From: Habib, Donald
Sent: Wednesday, June 20, 2012 8:52 AM
To: john.mcconaghy@duke-energy.com
Subject: FW: Draft LNP RAI response - Seismic Evaluation
Attachments: RAI L-0998 Response Outline 06-18-12.pdf

NRC RAI

Response L-0998 Outline:

Figure RAI L-0998-1: Comparison of hard rock UHRS based on the EPRI-SOG/UCSS model from FSAR with hard rock UHRS using CEUS SSC model.

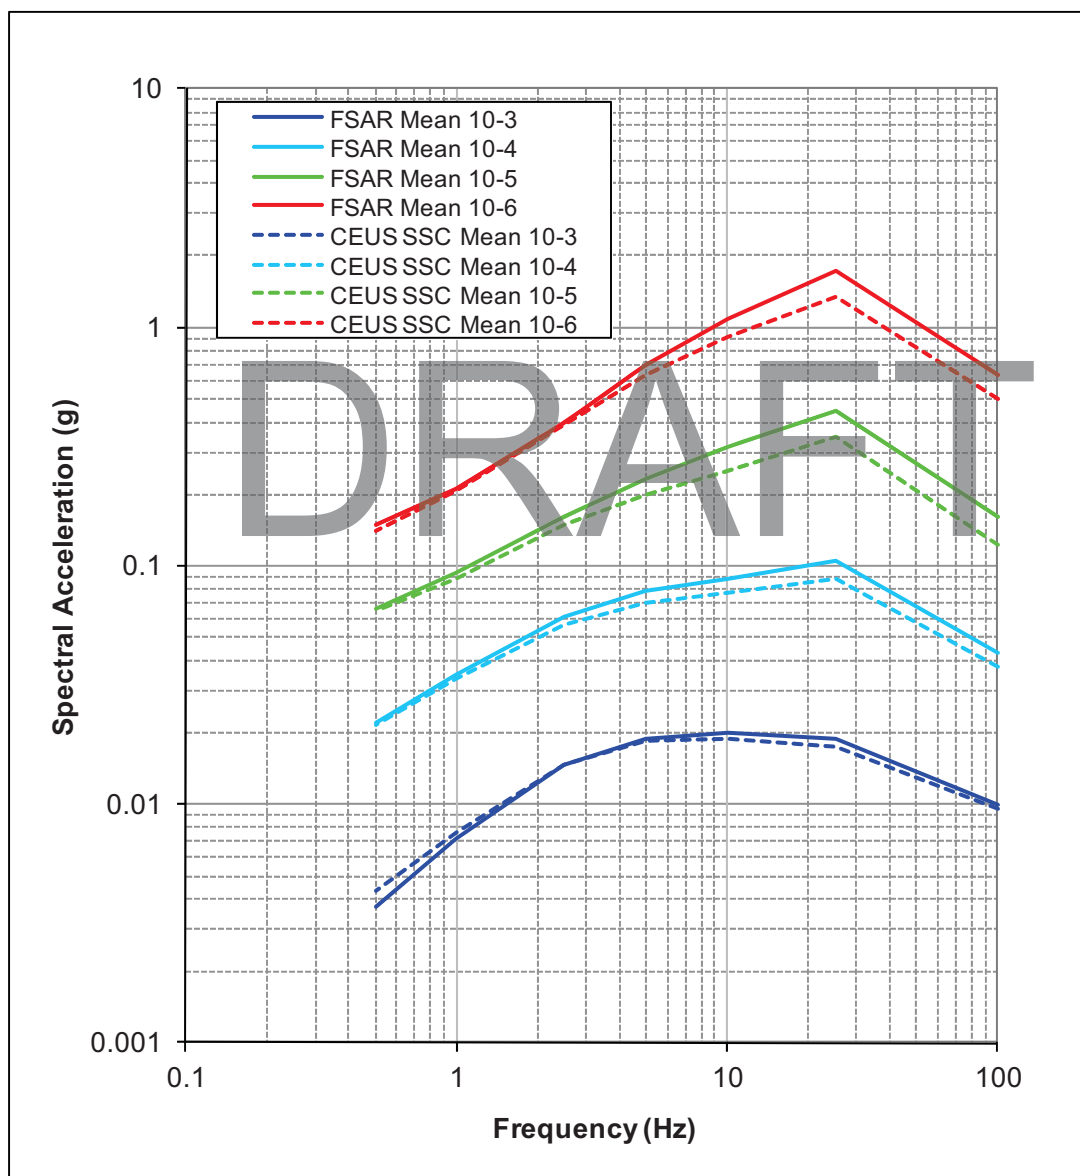
Evaluate the seismic hazard at your site against current NRC requirements and guidance and, if necessary, update the design basis and structures systems and components important to safety to protect against updated hazards (seismic portion only – of detailed Recommendation 2.1 – Enclosure 7 of SECY-12-0025).

Figure RAI L-0998-1 compares the hard rock UHRS based on the EPRI-SOG/UCSS source model used in the FSAR to the hard rock UHRS based on the CEUS SSC source model. The rock UHRS based on the CEUS SSC model are somewhat lower at spectral frequencies above 2.5 Hz and are similar to the Calculation LNP-0000-X7C-031 results for lower spectral frequencies. The only place where the CEUS SSC model produces higher motions is for the 10^{-3} UHRS at low frequencies. This higher hazard is likely due to the larger maximum magnitudes for the distributed seismicity sources in the CEUS SSC model.
